Subject: Minutes of Meeting held on 29.08.2023 (Tuesday) at 03:00 PM to discuss operational Issues w.r.t. new STATCOMs at ISTS in RE complexes – reg.

Minutes of Meeting held on 29.08.2023 (Tuesday) at 03:00 PM to discuss operational issues w.r.t. new STATCOMs at ISTS in RE complexes – reg.

Requirements w.r.t to Future STATCOMs shared by GRID-India and CTUIL

Figure 1: STATCOM Components and SLD

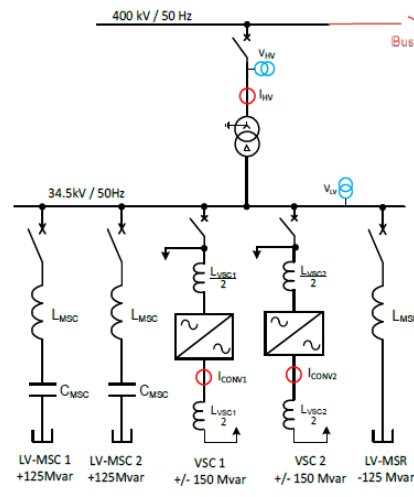
GRID-India: - STATCOM sizing is an important aspect in view of managing the voltage changes in steady state as well as transient conditions. At present, the STATCOMs are being installed with MSC and MSR units. The requirement of providing MSC and MSR vis-à-vis complete dynamic capacity needs to be analyzed especially in RE complexes where the requirement is mainly of dynamic reactive power support.

Further, the dynamic capacity of STATCOM is being provided in modular units, i.e. 02 units of +/-150 MVAR are being installed to meet the approved requirement of +/- 300 MVAR.

Hitachi Energy: - Instead of writing "N-1" criteria for transformer spare which might mis-lead in interpreting the requirement, it is suggested to clearly specify the number of spare power transformers required per STATCOM station or per site. Further it should also be clearly mentioned, How the spare transformer change over should happen replacing the faulty one (autochange over with disconnectors or manual change over). Should the spare transformer be cold-standby or Hot stand-by.

Further w.r.t to sizing of STATCOM, it submitted that due to advancement in semiconductor technology, we have IGBT cells of higher rating which are being used in the global market. In order to avoid the issues with complex control system (Master/Slave) with multiple VSC branches of smaller size, it is suggested to adopt the single VSC branch of higher rating (i.e., Ex: Use single 300 MVar branch instead of 2X150 or 4X75 MVar)

Hyosung: - Regarding redundancy in coupling transformer, as Hitachi mentioned that the requirement of spare power transformers needs to be incorporated in the RfP document. Further, it should also be clearly mentioned whether the spare transformer changeover would be autochange over with disconnectors or manual change over.

Regarding Sizing of STATCOM, Hyosung can provide maximum 300 MVar capacity STATCOM as a single unit however is its more than 300MVar, then it will be provided in modular units. Similar practice is being followed in other countries and its working satisfactorily. There will be no co-ordination issues even in multiple branches of VSC as there are some countries where we have supplied even 4 and 7

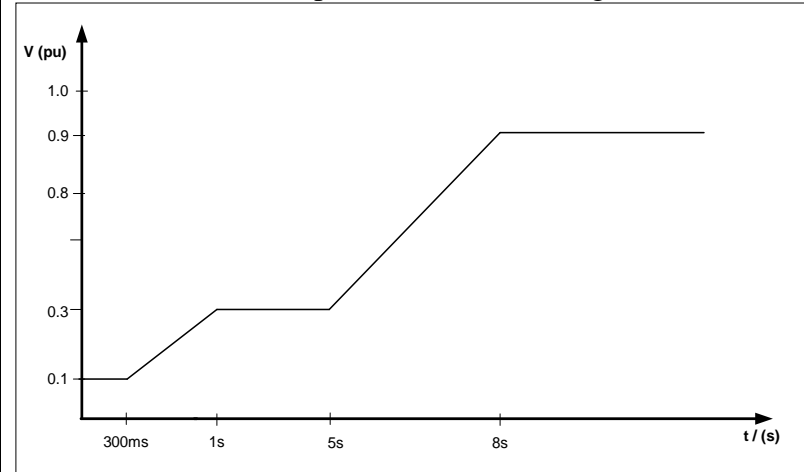
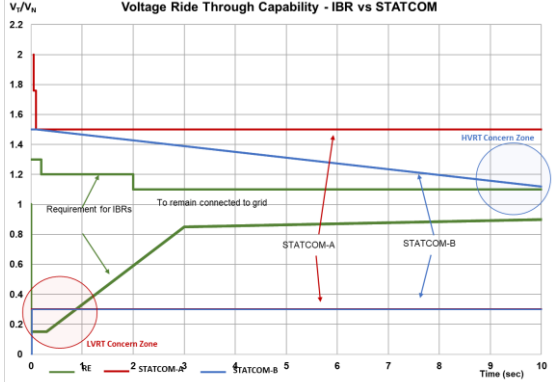
From system reliability point of view, it is desirable that the STATCOMs envisaged in RE complex remain connected even when voltages dip up to 0.15 p.u. at the HV side of the coupling transformer and provides the necessary dynamic support during faults/voltage dip events in the vicinity of RE plants. This necessitates that the LVRT thresholds of STATCOMs are more robust (Lower voltage and higher time delay) than the thresholds mandated for RE plants in CEA technical standards for connectivity. However, it has been observed that the STATCOMs commissioned/under commissioning stage in Indian power system have their LVRT threshold in the range of 0.3-0.35 p.u. i.e. if the primary line-to-earth or line-to-line voltage drops below the voltage level of 0.3 p.u., the STATCOM output will be set to zero instantaneously.

The low voltage ride through capability of RE v/s some of the STATCOMs commissioned in Indian power system are shown in figure-2 below:

Hitachi: At low voltages, it is not possible to provide rated reactive power capability. Instead the available current/reactive power capability can be met.

<p>Figure 2: Voltage Ride Through: IBR v/s STATCOM</p>	 <p>Fig 4</p>
<p>In view of above, it is suggested that this aspect regarding STATCOM LVRT settings may be suitably addressed in the RfP/Technical Specification of upcoming STATCOMs.</p>	<p>Hysoung:- The requirement regarding the LVRT requirements for voltages mentioned are possible to provide and can be met.</p>
<p>HVRT threshold values of STATCOMs</p> <p>The STATCOMs being installed in RE complexes shall be capable to operate on continuous basis at least up to 1.1 pu voltage (HV side), which is also the high voltage threshold of RE plants for continuous operation. Further, some additional margin above this threshold shall be kept (preferably 0.05 p.u.) so as to ensure that STATCOM output is not blocked before 1.10 pu in case of some measurement error. Also, the HVRT threshold (both voltage and time delay) for STATCOM shall be higher than the over voltage stage-2 settings of HV lines in the RE complex (refer figure-2 above).</p> <p>The above-mentioned aspects may be suitably considered in the RfP/Technical Specification of upcoming STATCOMs.</p>	<p>Hitachi Energy: - In RfP document please add a curve for High voltage ride through requirements.</p>

Fig. 3

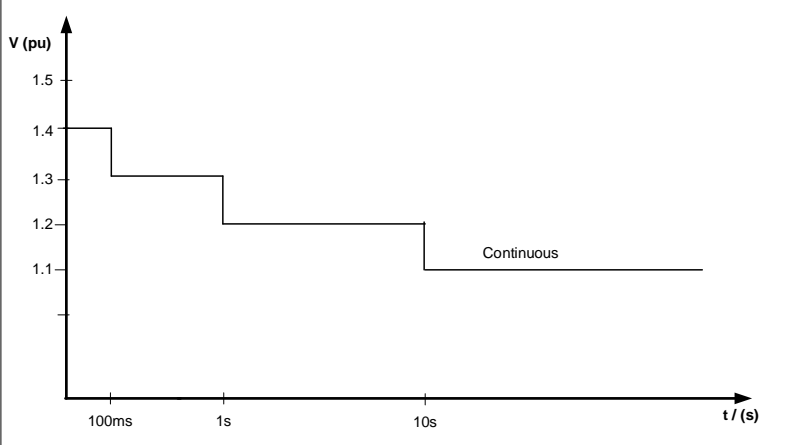
The indicative curve is presented below in Fig 3: -

The temporary overvoltage cycle shall be specified as a curve as the text description might lead to mis-interpretation.

A typical TOV cycle is presented below in Figure 4,

Figure 1 STATCOM Station Voltage ride through characteristics

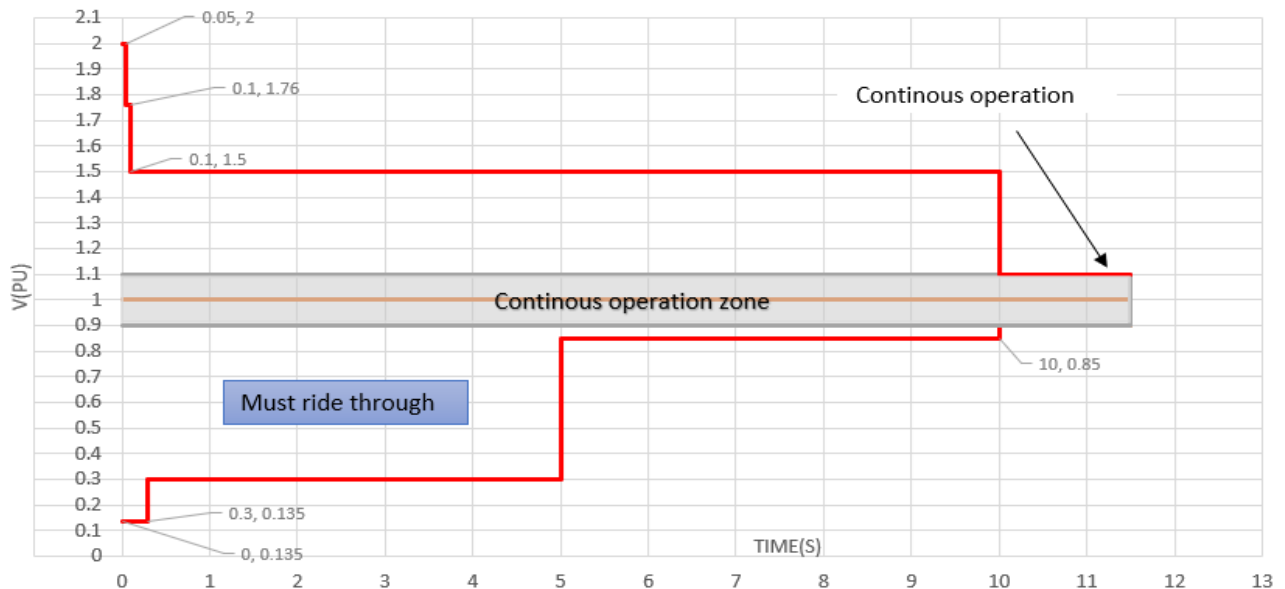
The STATCOM Station shall be capable of ride through for voltage disturbances (dips/swells) at PCC/POI as per the Voltage versus time characteristics as depicted in Table-1 and Figure-1. For a given voltage, the STATCOM Station shall not trip/block until the time duration at this voltage exceeds the specified minimum ride-through time duration. The required minimum ride-through time duration is a cumulative time within a 10-sec time window for one or multiple voltage dips/swells.

However, for voltage beyond LVRT/HVRT curve, STATCOM can block/trip. STATCOM Station shall have the capability for continuous operating in 0.9 to 1.1pu voltage.

The Voltage ride-through requirements specified in these provisions shall be applicable at POI/PCC. Accordingly the LVRT/HVRT settings at the corresponding VSC unit shall be coordinated so as to meet the ride-through requirements at PCC/POI. The Voltage versus time curve for LVRT/HVRT capability is given at Fig.1.

The voltage ride through curve to be considered in RFP may be finalized after taking views of other members:

Figure 2 Multiple ride through requirements for voltage less than 0.5pu

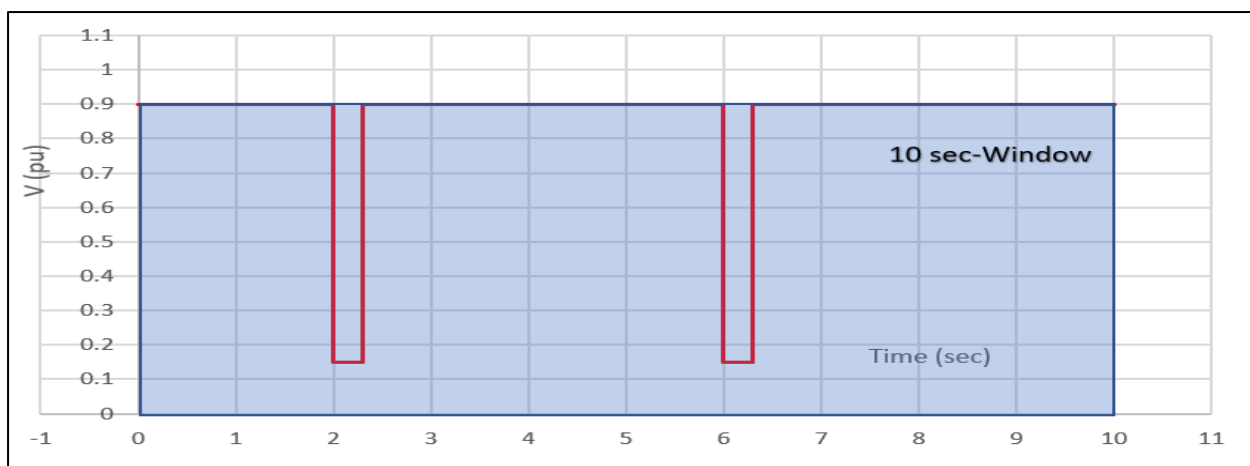
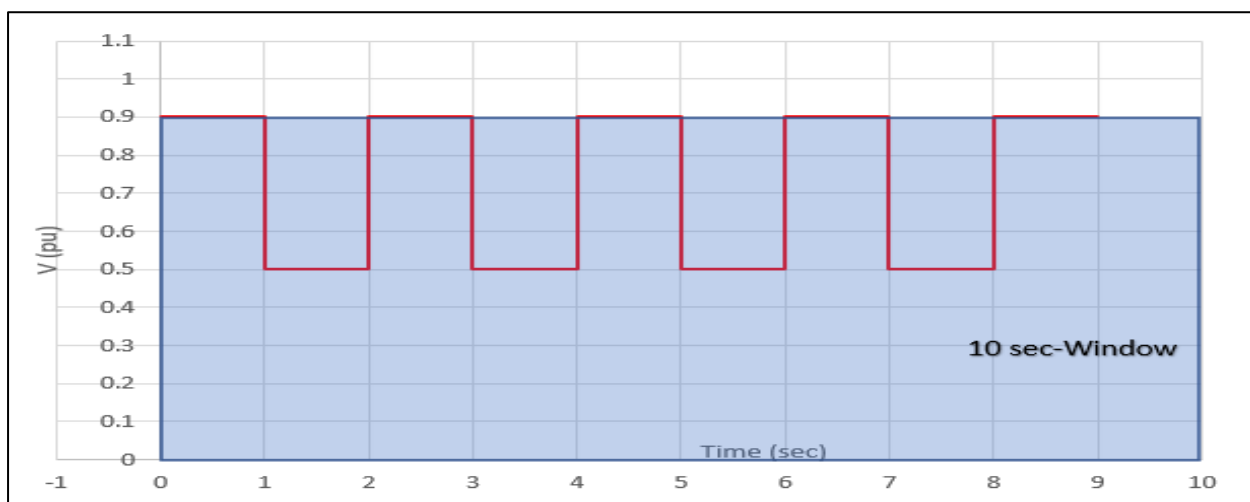
Considering the fact that Inverter Based Resources (IBR) resources and STATCOMs are a matching technology, accordingly, the following provisions w.r.t multiple ride through (voltage) can be inserted in RFP after considering views of OEMs and other member:

- a) The STATCOM **may trip/block for more than four deviations of the voltage at the POI/PCC upto 50%** of the nominal voltage outside of the continuous operation region within any 10-s period.
- b) The STATCOM **may trip/block for more than two individual deviations of the voltage at the POI/PCC below 50%** of the nominal voltage within any 10-s period.

Since, the inception of subsequent fault occurrence cannot not be anticipated, therefore the time gap between subsequent voltage dips is not specified therein.
